**PLANS AND DOCUMENTS
referred to in the PDA
DEVELOPMENT APPROVAL**

Approval no: DEV2022/1290

Revised Statement of Landscape Intent

17 Weinam + 57 Hamilton Street

2.10 Landscape Plan Fence & Edges Ground Level

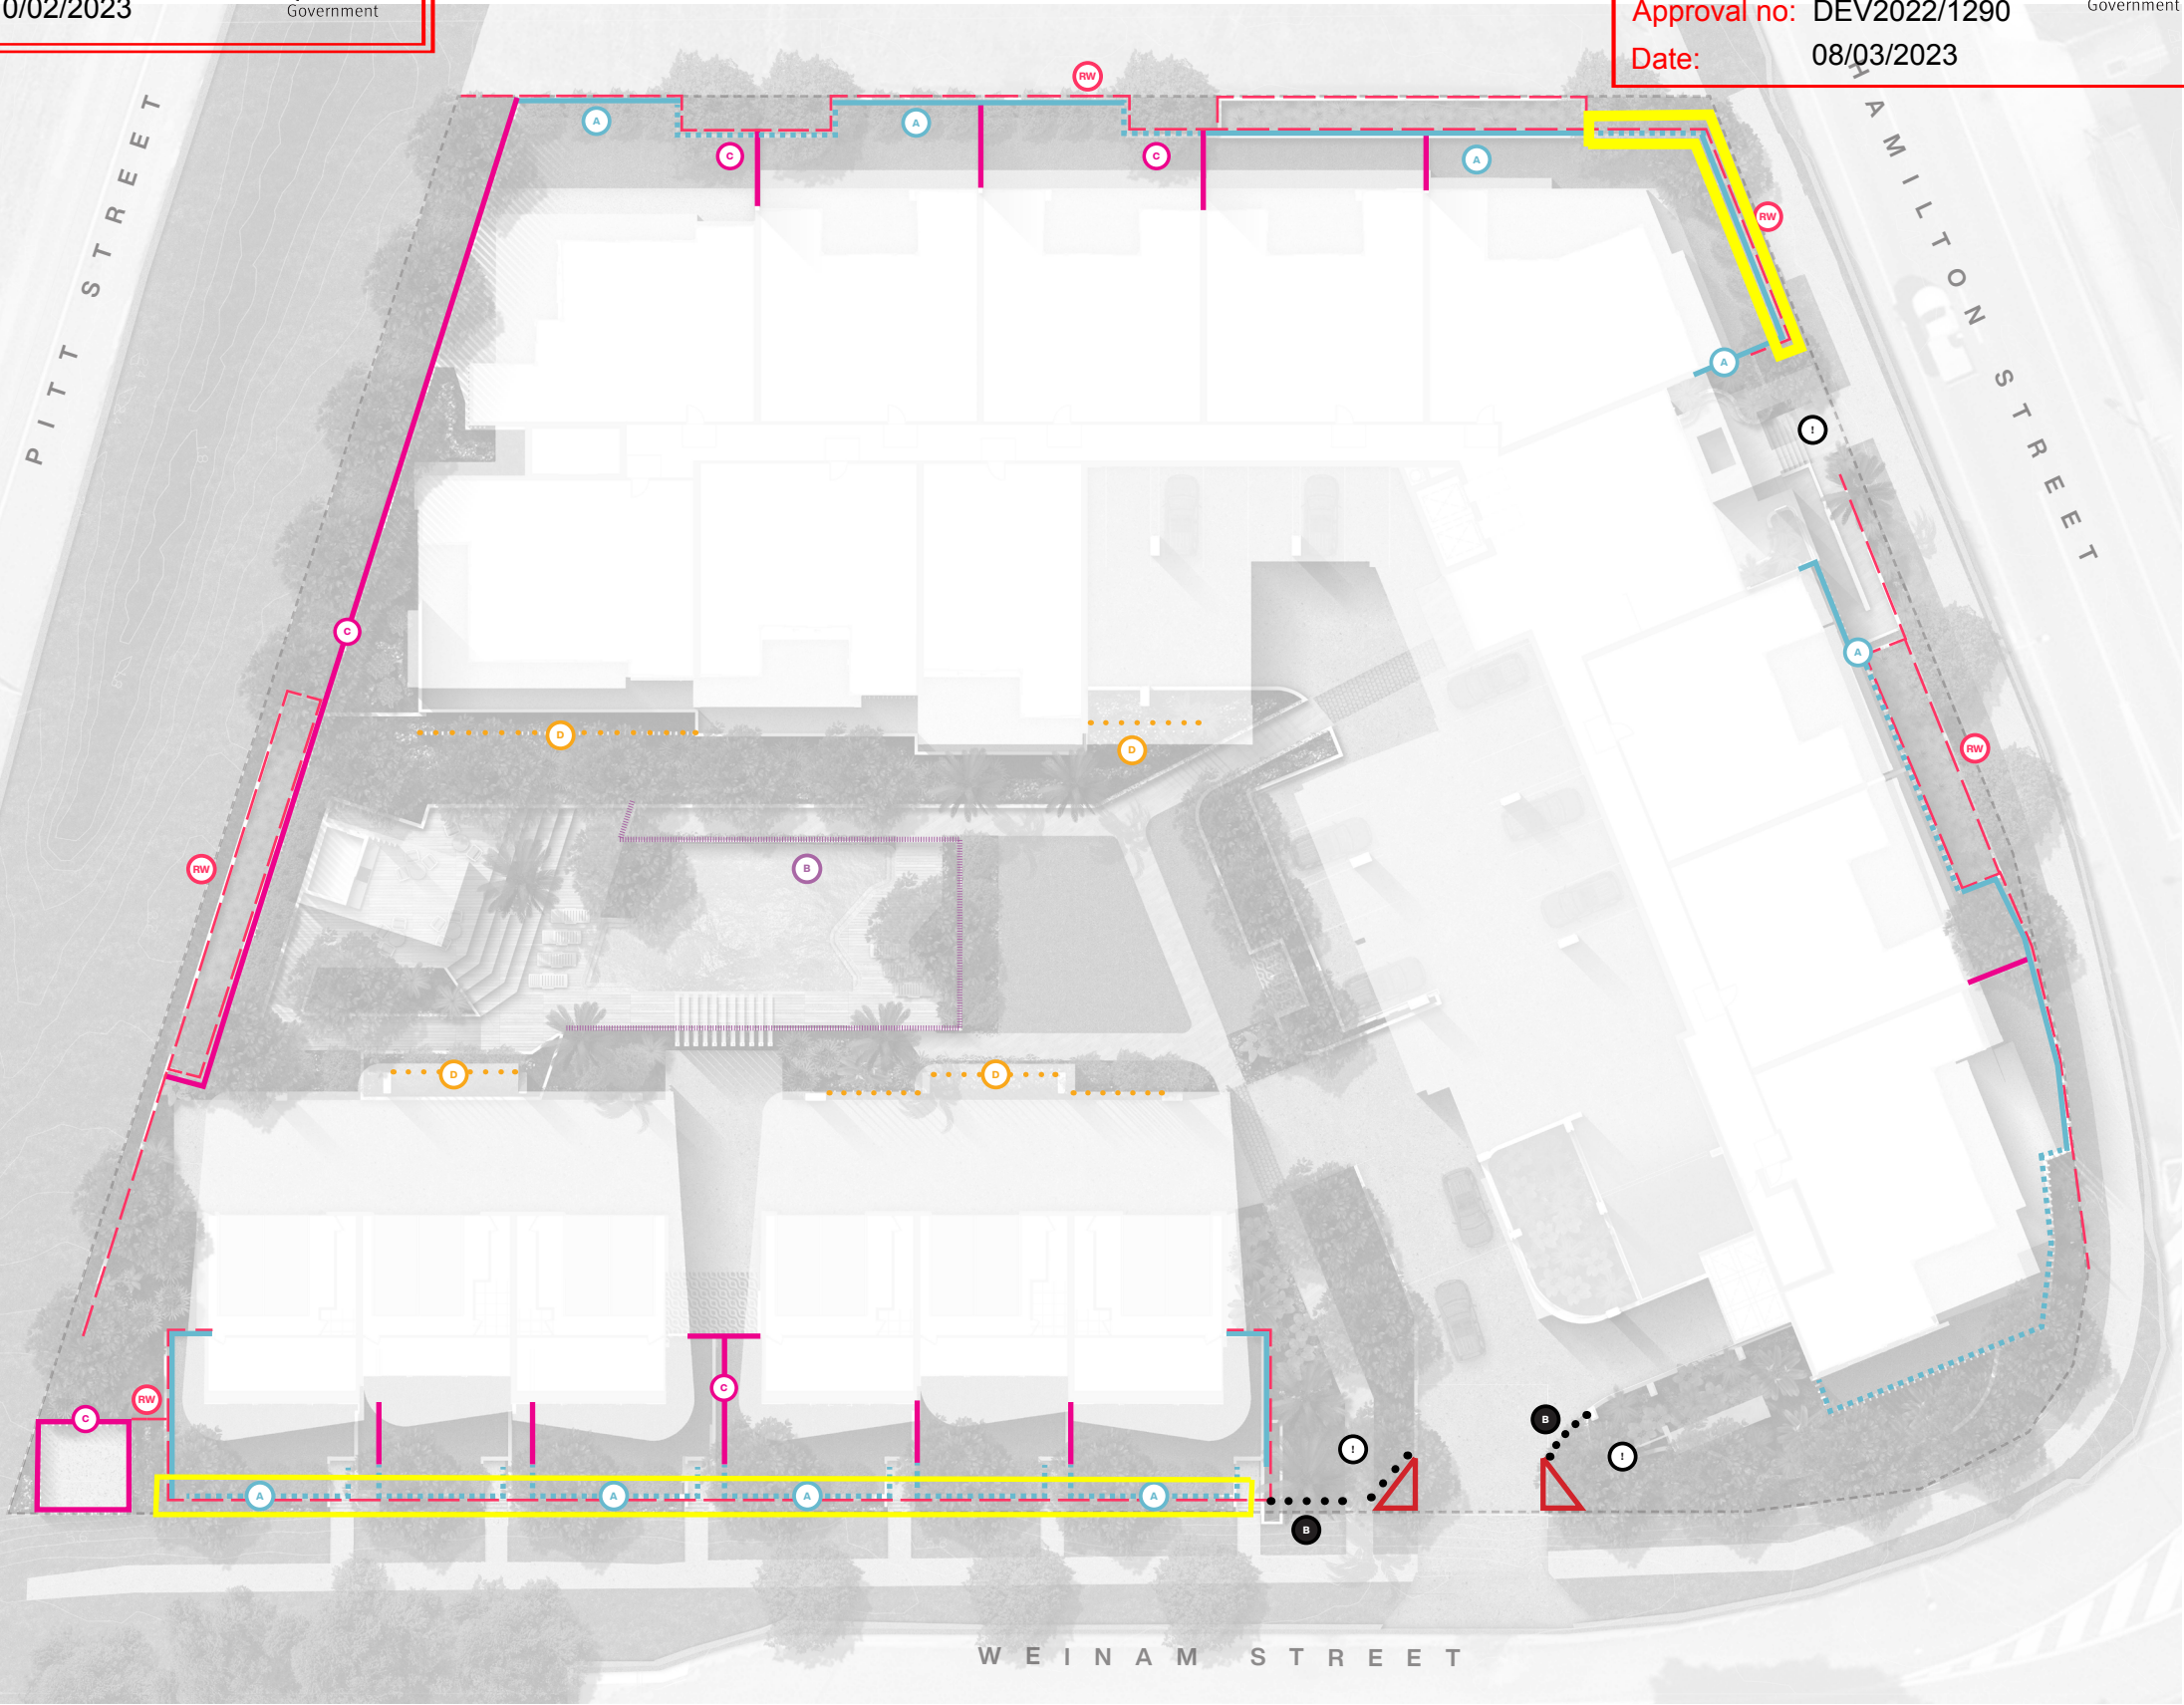
Boundary fencing and retaining wall
design is subject to compliance
assessment under the requirements
of condition 29

Note: Retaining wall locations included for reference only. Refer to civil engineering plans for all details regarding retaining wall heights, location and alignments. This plan set does not seek approval for any retaining structures.
